DESIGN #	DRAWN BY CP	DART AEROSPACE LTD HAWKESBURY, ONTARIO, CANADA	
CHECKED #	APPROVED #	DRAWING NO. DSI 9257	REV. A SHEET 1 OF 1
DATE 03.03.20		TITLE RACK & RESERVOIR ASSEMBLY	SCALE NTS
A	03.03.20	NEW ISSUE

## **DART SERVICE INSTRUCTION**

TO AMEND BHA-DRA-358-11 SHEET 2, REV. C

AND IIN-D206-590 REV. NI

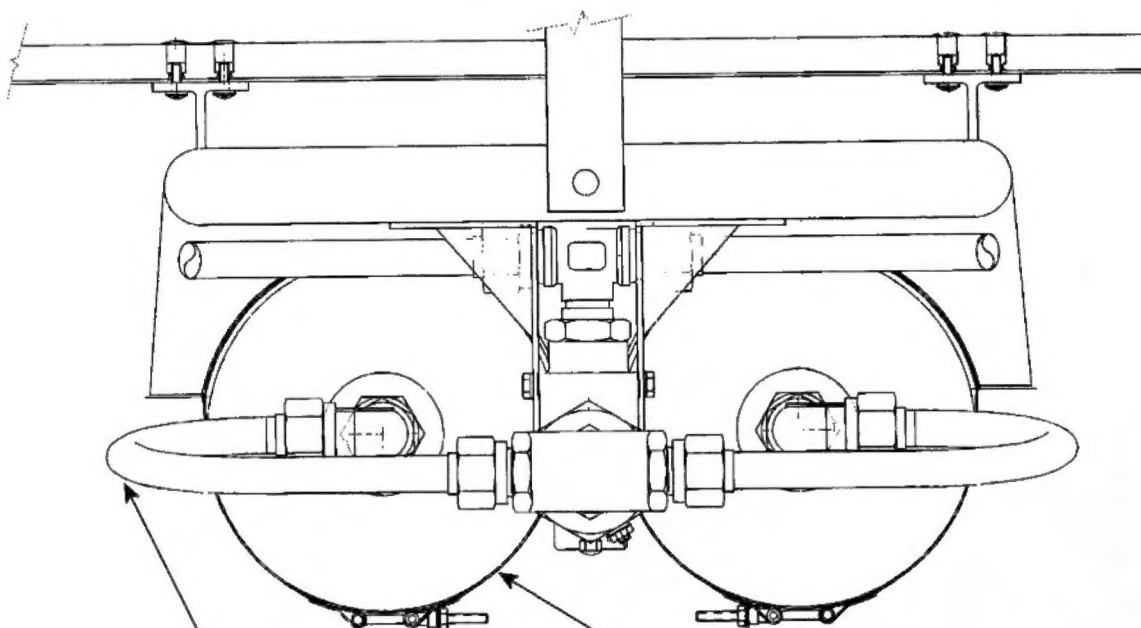
THE FOLLOWING CHANGES HAVE BEEN MADE TO THE RACK AND RESERVOIR ASSEMBLY  
(REF. HELITECH P/N 358-021-001 & DART KIT P/N D206-590-017):

469-035-002 TUBE ASSEMBLY (2)  
REPLACES 358-035-011 TUBE ASSEMBLY (2)

MS20426AD3-6 RIVET (12)  
MS21920-61 CLAMP (4)  
MS27833-6-300 PAD (8)  
REPLACES 358-027-001 BOTTLE CLAMP (2)
